8D Report

Customer: Precision Hydraulics Private Limited

Part Name: 4002674 - Head

ATL Part no.: A9327

Gland Bend Issue

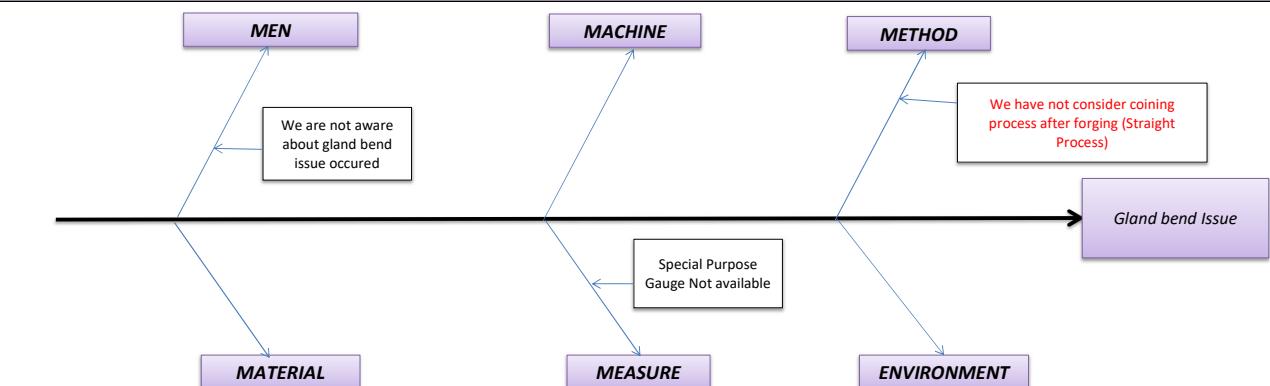
1.) Customer Complaint

1.) Why was the non conformity made?	2.) Why Was the non conformity not detected?
Why? We have not consider coining process after forging (Straight Process)	Why? 100% Inspection not carried out at Final inspection stage
Why? We are not aware about gland bend issue occurred	Why? Special Purpose Gauge Not available
Why?

1. We have not consider coining process after forging (Straight Process) 2. We are not aware about gland bend issue occurred 3. Special Purpose Gauge Not available	Responsibility	Responsibility
	Mr. Bipin	Mr. Vikaram
	Department	Department
	Production	QC

- 1 We have started the coining process for eliminate Bend issue in which have available Forging stock at our end.
- 2 Quality Alert to be displayed at work station
- 2 100% Parts should be checked before dispatch

Action:	Responsibility	Target Date
1.) We have add & started the coining process for eliminate Bend issue.	Mr. Bipin	already started
2.) We will introduce the Special Purpose Gauge.	Mr. Vikaram	30-04-2025
